REGIONAL REVIEW FINDING

ARC REVIEW CODE: R1602161

Name of Proposal: Civic Center Mixed-Use

Review Type: Development of Regional Impact **Date Opened:** Feb. 16, 2016 **Date Closed:** March 7, 2016

A01

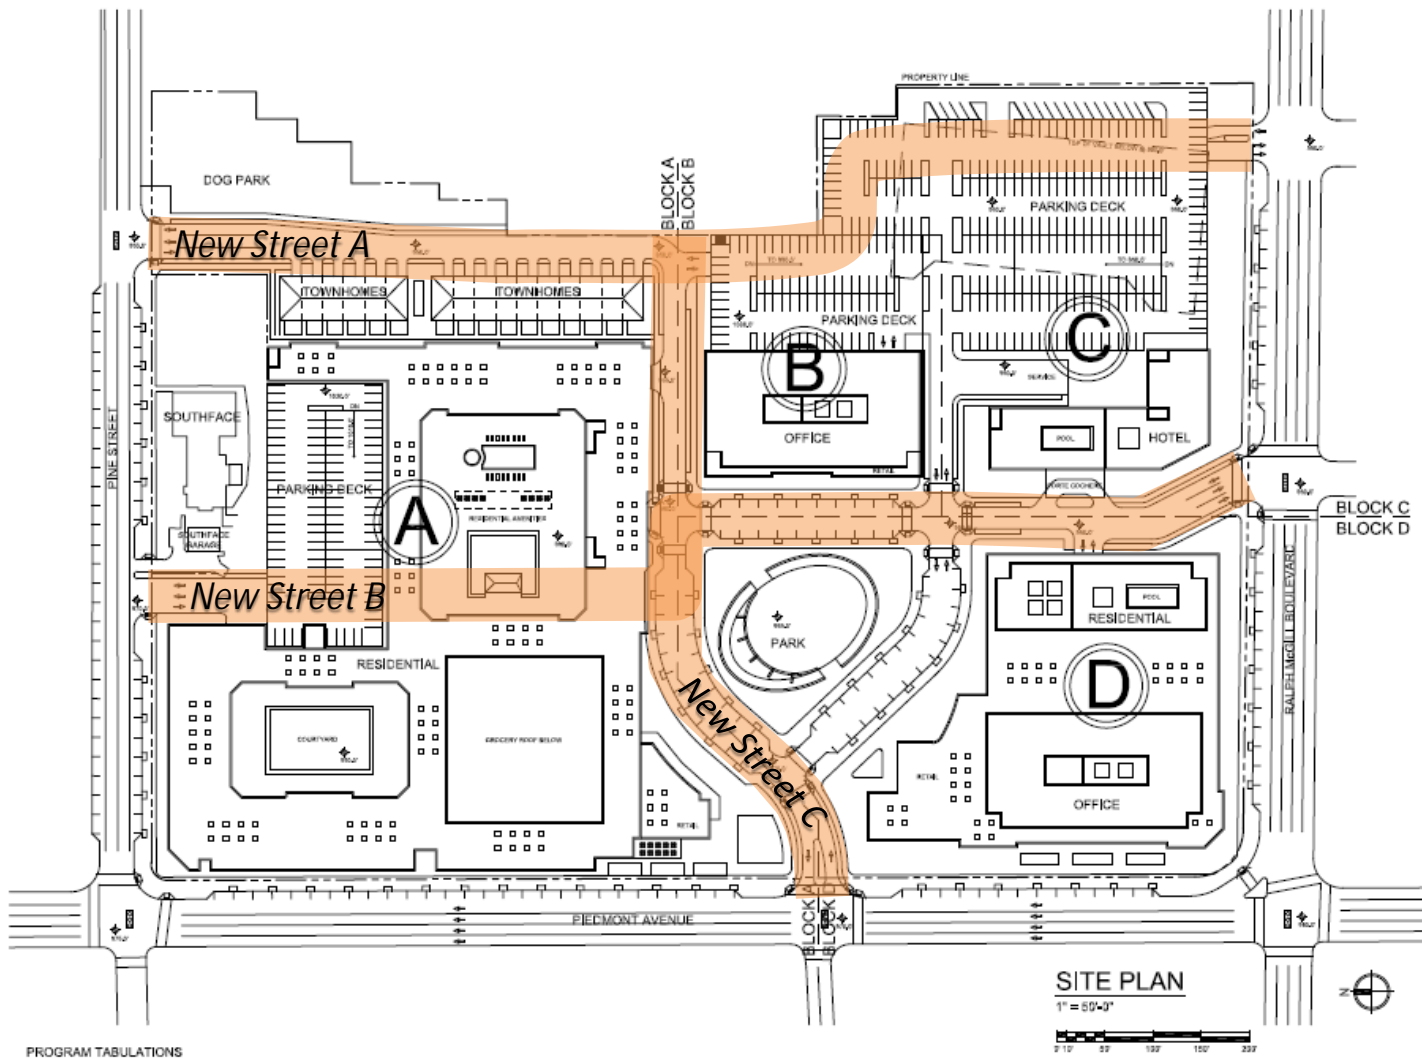
1. The site be further divided by fully publicly accessible streets to divide the site into smaller, more pedestrian-friendly blocks. Downtown Atlanta typically has block faces of between 350 and 400 feet and the the Civic Center site should reflect a similar grid pattern. Attached, find a conceptual diagram of how the site could be further divided by streets.

2. Pine St should be reconfigured with parallel parking on both sides of the street and one travel lane in each direction. The slip lane at the intersection of Pine St and Piedmont Ave should be closed. The intersection of Pine St at the Piedmont Ave should be realigned (the intersection is slightly offset). Finally, the development should not introduce a new traffic signal on Pine St serving either of the development driveways.

3. Piedmont Ave should be reconfigured. Looking north, beginning at the western curb line: parallel parking lane - three 10' wide travel lanes - parallel parking lane - 3' wide protected buffer - 6' wide bicycle lane. See: http://streetmix.net/JonathanSLewis/45/piedmont-ave--currier-st<http://streetmix.net/JonathanSLewis/45/piedmont-ave--currier-st#_blank>
[cid:image002.jpg@01D174AE.E666BFC0]

4. R. McGill Blvd should be reconfigured. See page 78 of the Cycle Atlanta: Phase 1.0 Study (minor revisions should be considered to create consistent 10' travel lanes on R. McGill Blvd, along these lines, looking west: http://streetmix.net/JonathanSLewis/46/r-mcgill-blvd--civic-center-driveway<http://streetmix.net/JonathanSLewis/46/r-mcgill-blvd--civic-center-driveway#_blank>).
[cid:image004.jpg@01D174AE.E666BFC0]

DRI SITE PLAN

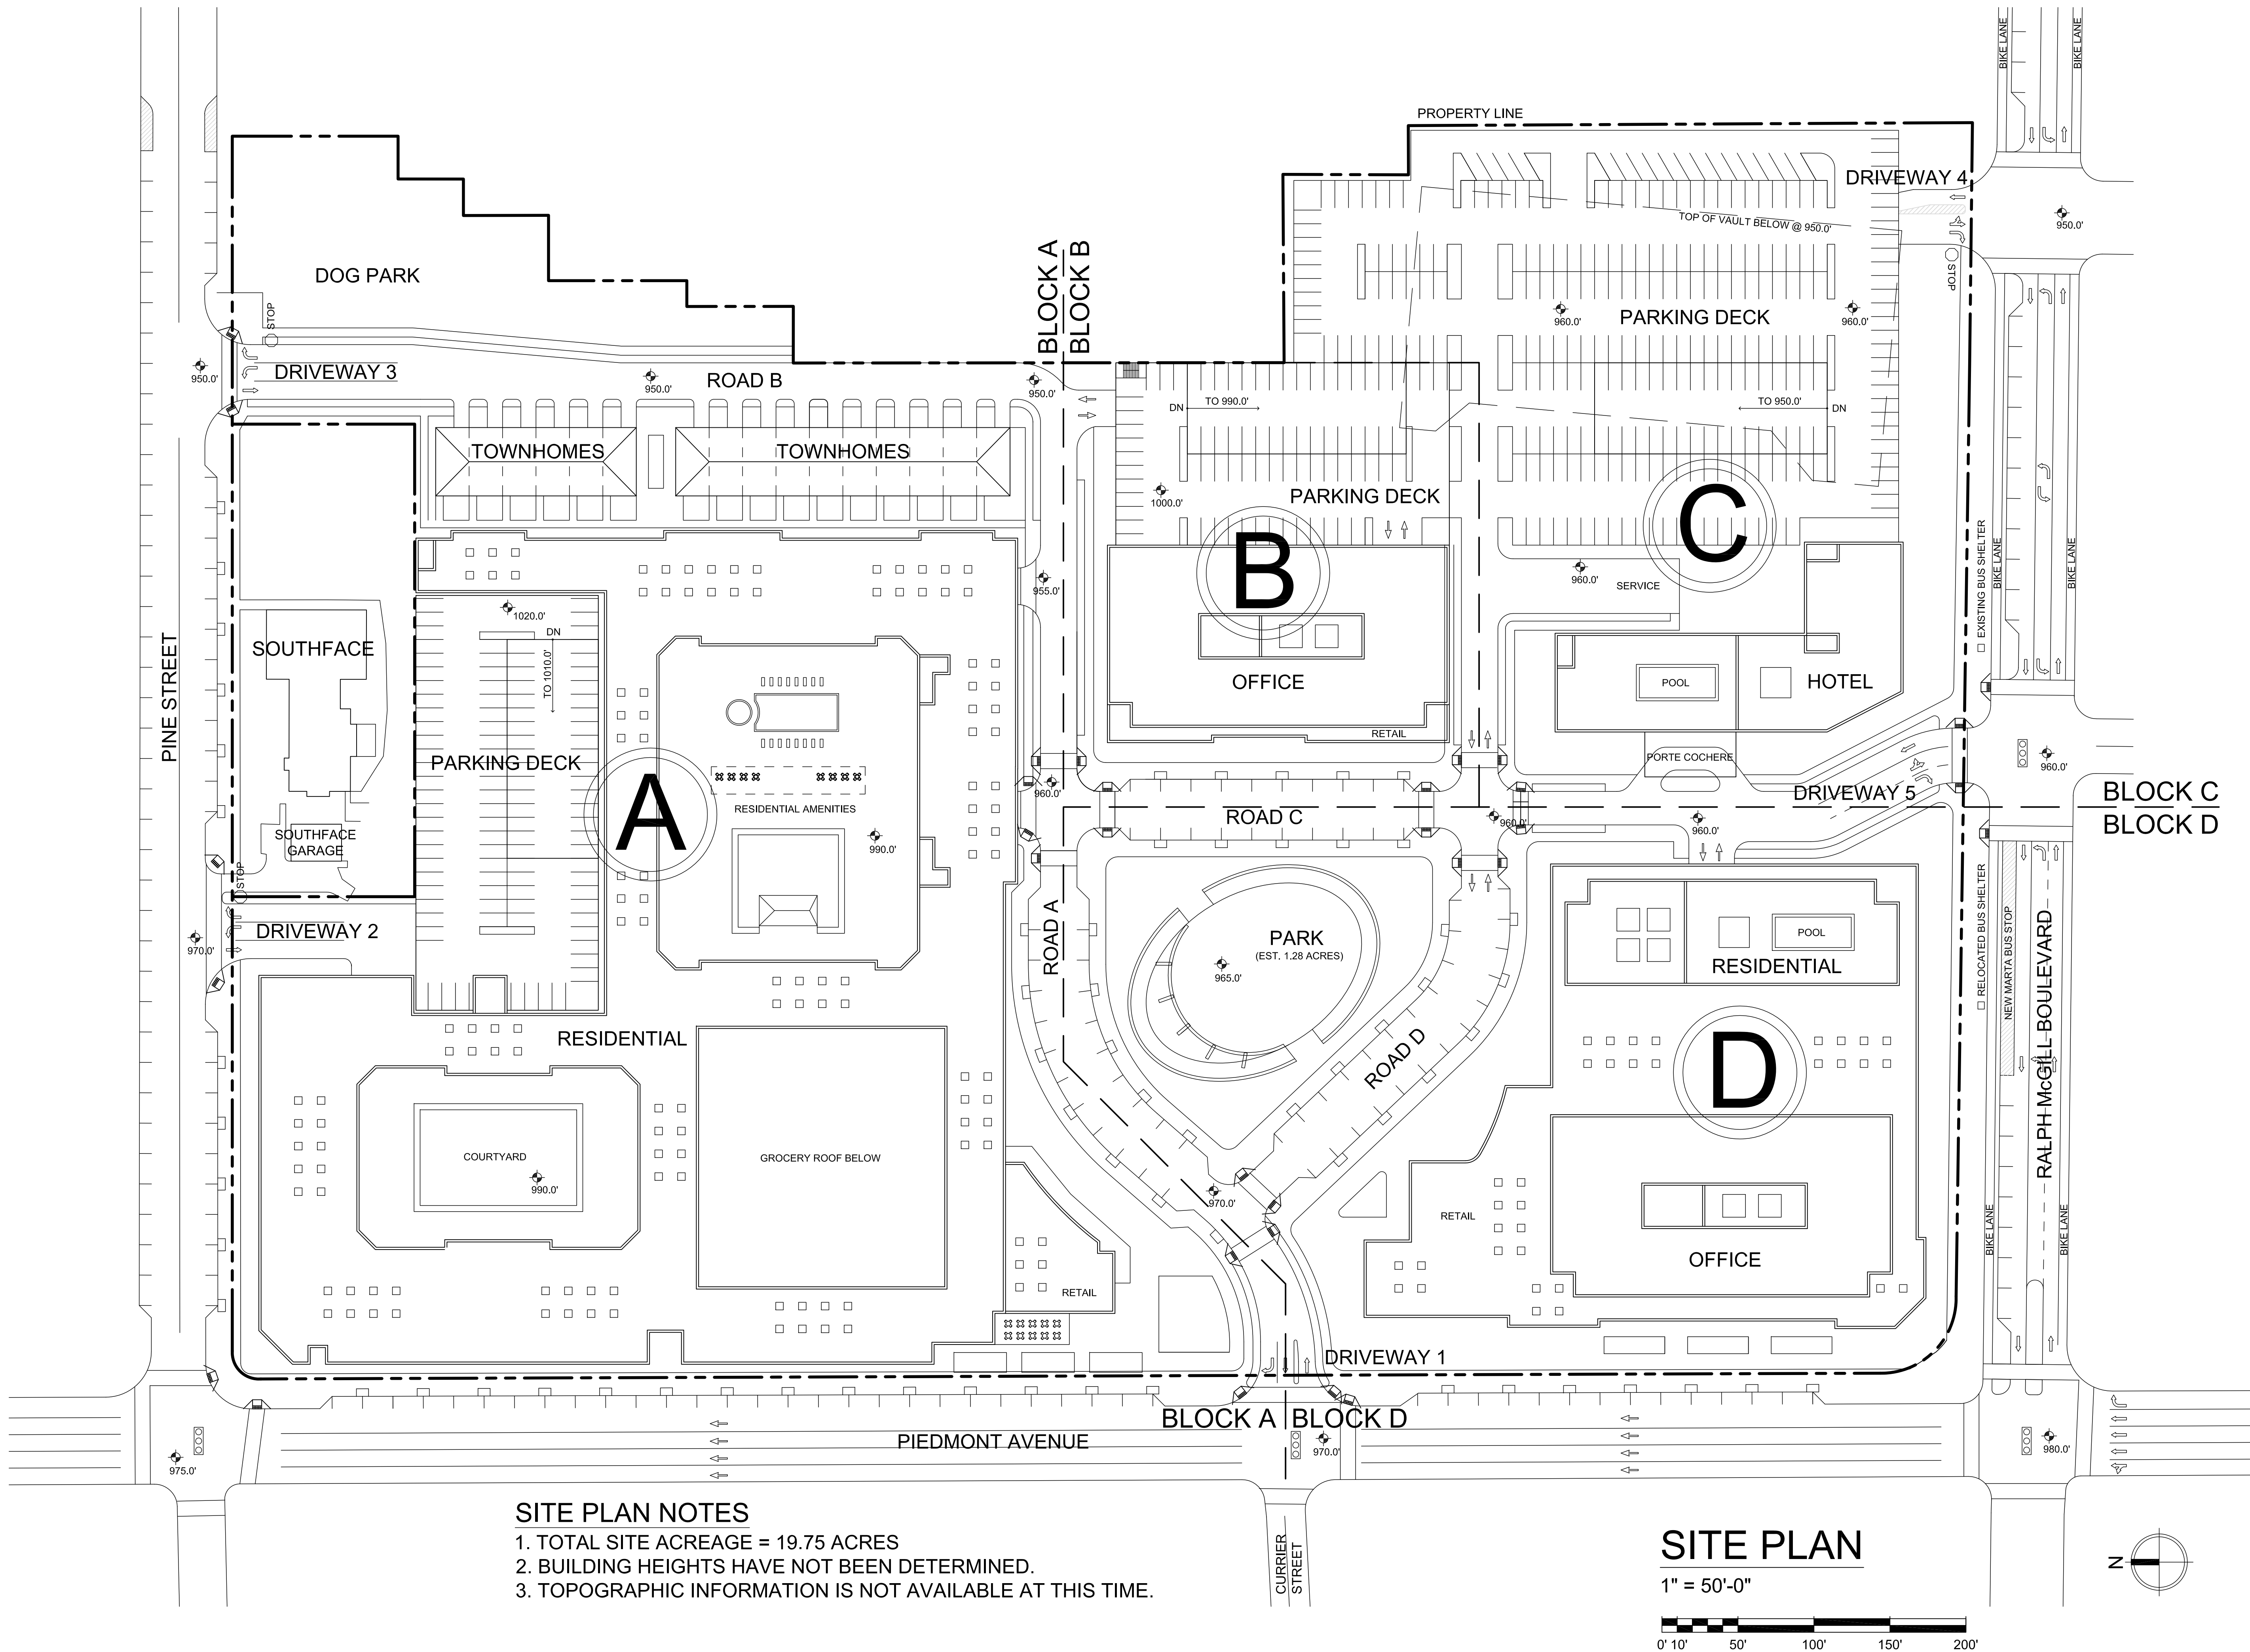
- **Site Plan Street network** – CAP/ADID supports a site plan that provides ease of access for pedestrians and inter-parcel connectivity. CAP/ADID recommends further subdividing the planned street network with a goal of reducing block sizes to a more typical Downtown block size of 350' to 400' in length and to promote better connectivity through and around the site. Block A is particularly problematic. It blocks connectivity and pedestrian access from the south end of the site to Pine Street and Renaissance Park to the north. The block face along Piedmont Avenue is too long to support a quality pedestrian experience.

While presented with limited information, the site plan seems to reflect a more suburban, auto-based design and is not in keeping with the vision of Blueprint Midtown. Interior circulation within the development is lacking, particularly the east/west connections. Additionally, the number of curb cuts seems excessive.

Piedmont Avenue has plenty of excess capacity that can be repurposed for other uses. Midtown Alliance supports the repurposing of a through lane on Piedmont Avenue for on-street parking as shown on the plan. We recommend that the applicant also pursue the development of a barrier separated one-way bicycle facility adjacent to the on-street parking. The City of Atlanta in partnership with Midtown Alliance plans to build a one-way bicycle facility north of this site as part of the Renew Atlanta Bond Projects. Additionally, we recommend that the applicant consider the addition of a protected mid-block pedestrian crossing on Piedmont Avenue between Currier Street and Pine Street. The block length is approximately 700' which is excessive for an urban area.
